Subject: Battery Compartment Cable Routing Inspection & Correction			
Field Change Program: Field Campaign	FCP Number: 491	Revision: A	Date: 02/22/2021
Coach Section: 07-Electrical	P/N: N/A		Type: Safety Recall

Ref. NHTSA Recall No.: 21V-063	Ref. Transport Canada Recall No.: 2021-058
--	--

Power cables with inadequate clearance from other items of equipment, may chafe which increases the potential for vehicle fire.

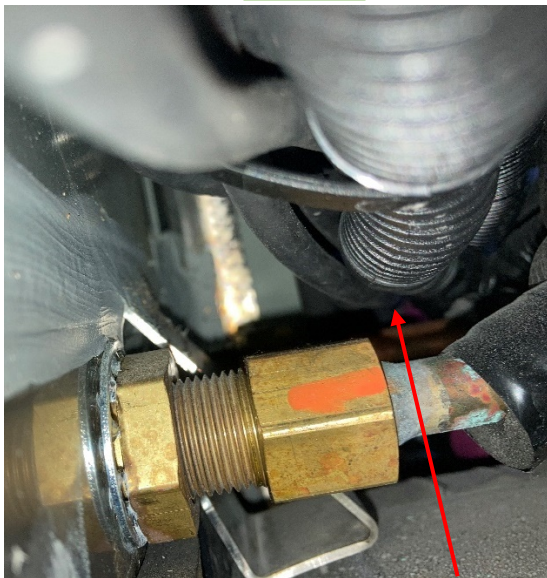
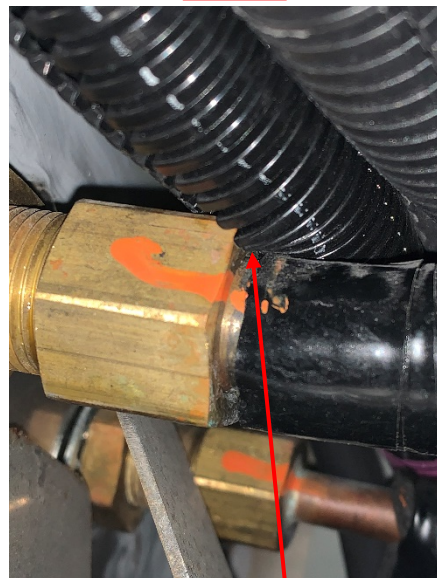
Open battery compartment door and verify if any of the power cables are in contact with or are rubbing against the parcel rack A/C line copper fittings.

Cable touching copper fitting. Refer to Section 5.1 for routing correction

If cables are found to be touching or rubbing on the copper lines, refer to Section 5.1 for routing correction.

Gap between cables and fitting.
Continue with next steps of inspection

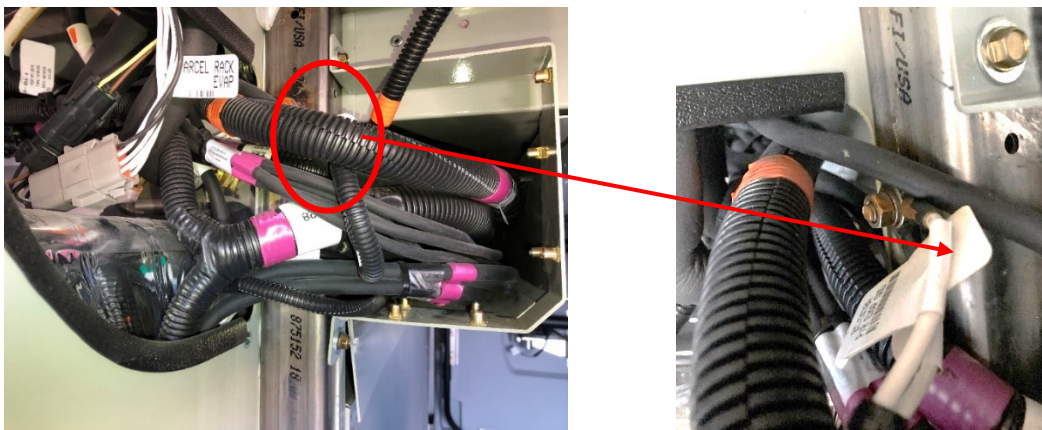
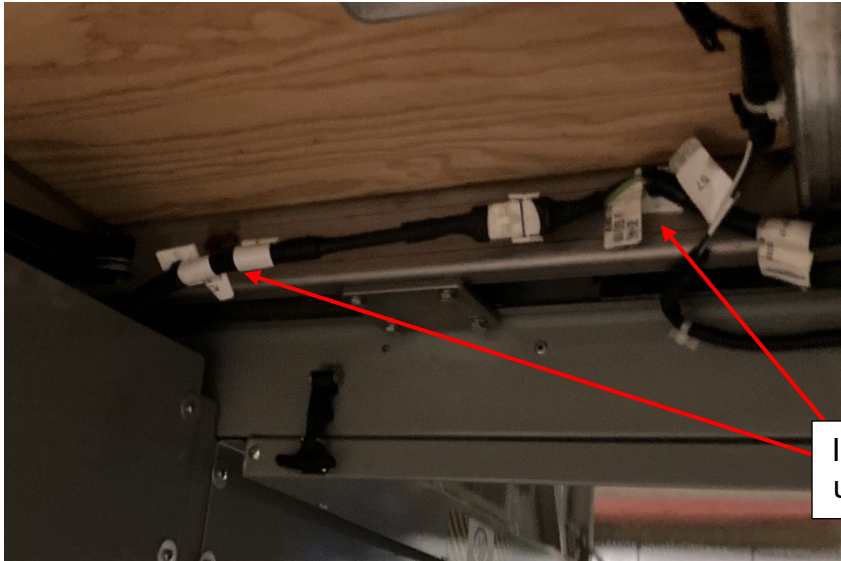
Inspect to see if cables are unsecured and close to the ground stud on the coach frame.

Cable close to ground stud. Refer to Section 5.2 for routing correction

If the cables are unsecured, refer to Section 5.2 for routing correction.

Gap between cables and ground stud. Continue with next steps of inspection

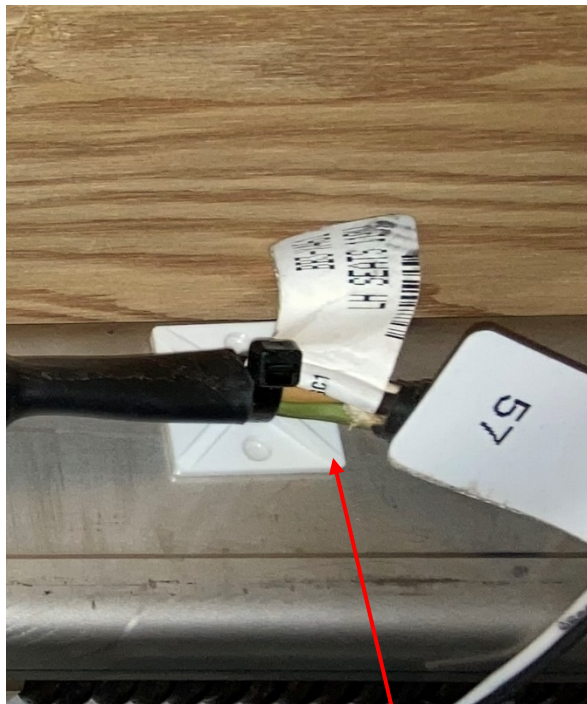
Inspect to see if the adhesive tie bases securing the 110V harness in baggage bay #3 compartment are still intact.

Adhesive base failed. Refer to section 5.3 for rework

If the adhesive tie base are failed, refer to Section 5.3 for routing correction. Otherwise, inspection is completed.

Adhesive base intact. Inspection completed.

5.1.2 Adjusting cable routing in battery compartment

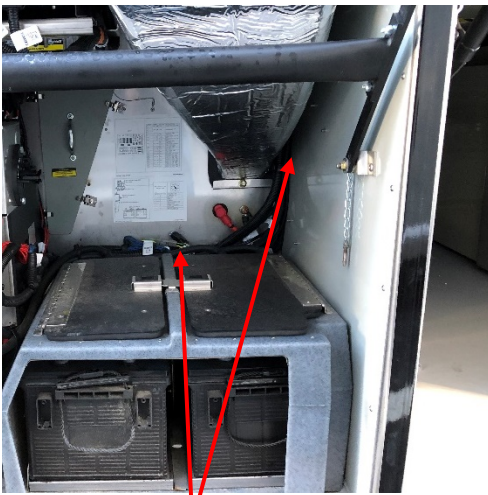
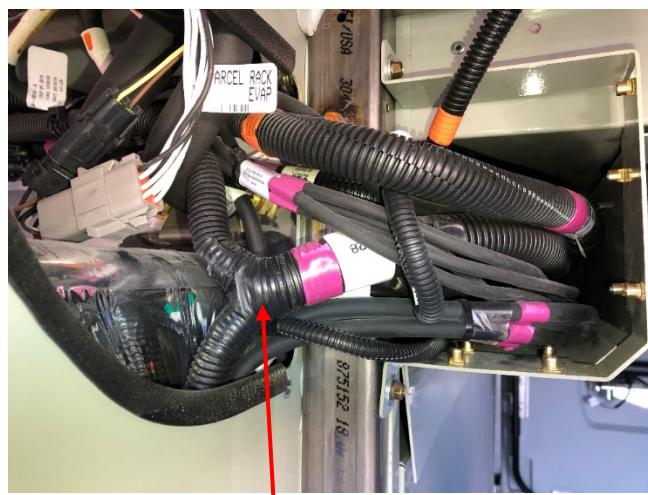
Cut the cable ties as needed behind the battery box and between baggage bay panel and HVAC duct to release tension in the center tunnel harness branch going over the evaporator coolant lines. Pull the center tunnel harness nearly 2" up.

Cut the cable ties as needed

Release the tension in center tunnel harness branch and pull it up by 2"

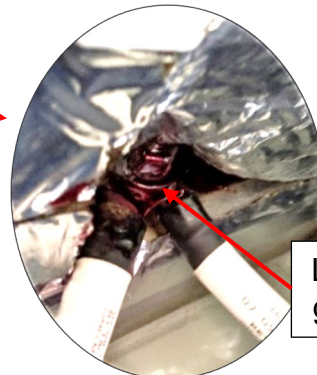
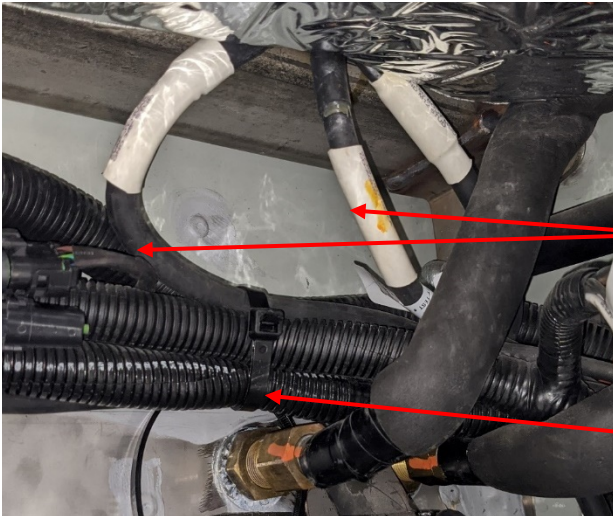
Loosen the ground cable stud and pull the ground cables outboard.

Loosen the ground stud

Pull ground cables outboard

Re-secure the cables using a cable tie, MCI P/N: 19-11-259, ensuring the ground cables are outboard. Torque the ground stud to 19 Ft-Lbs.

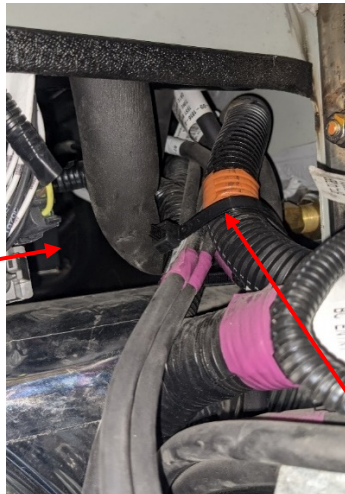
Pull the cables together and secure them with a cable tie, MCI P/N: 19-11-259, so that they move away from the fitting in the battery compartment.

Secure the cables with a cable tie

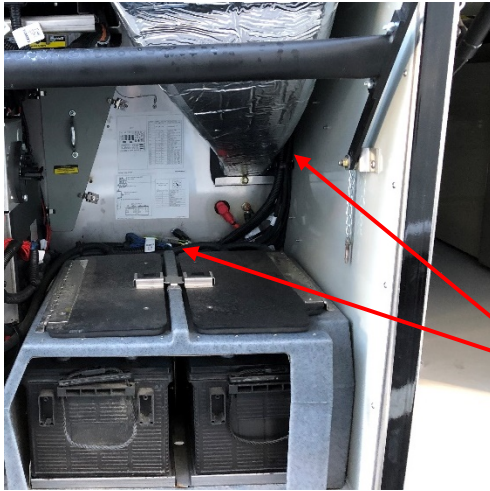
Secure the cables in battery compartment as required using cable ties, MCI P/N: 19-11-259.

Secure the cables using cable ties, 19-11-259

5.3.2 Re-installing adhesive tie bases

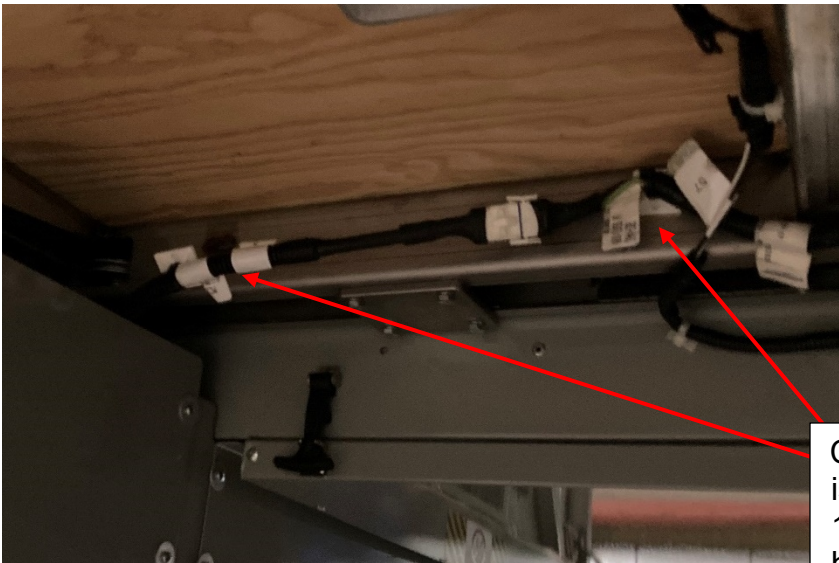
Cut the cable ties securing the 110V harness. Discard the tie base.

Clean the frame with isopropyl alcohol and install new adhesive tie bases, MCI P/N: 19-04-0283 and secure the cable with cable ties, MCI P/N: 19-11-259

Cut and discard cable tie and tie base

Clean the frame with isopropyl alcohol and secure 110V harness using tie bases, 19-04-0283, and cable ties, 19-11-259

6.1 Installing acorn nut

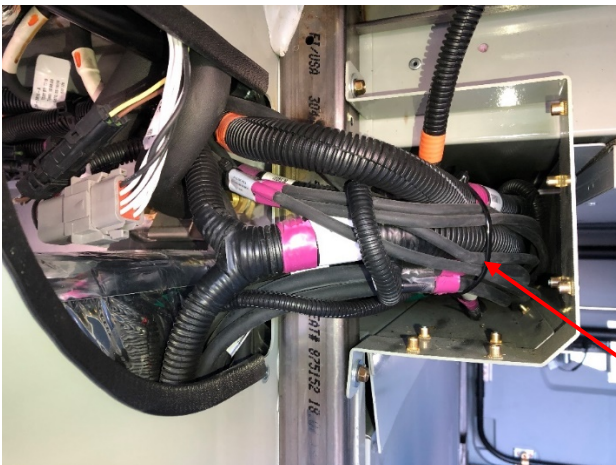
Install acorn plastic nut, MCI P/N: 6486917, to the ground stud.

Install acorn nut, 6486917, to the ground stud

Acorn nut, 6486917

6.3 Installing trimlock

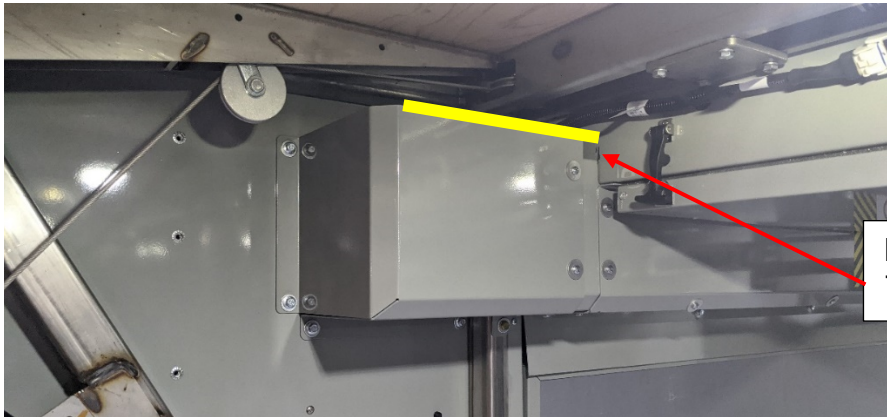
Install trimlock, MCI P/N: 21-7201-8, to the access panel front edge as shown below.

Install trimlock, 21-7201-8
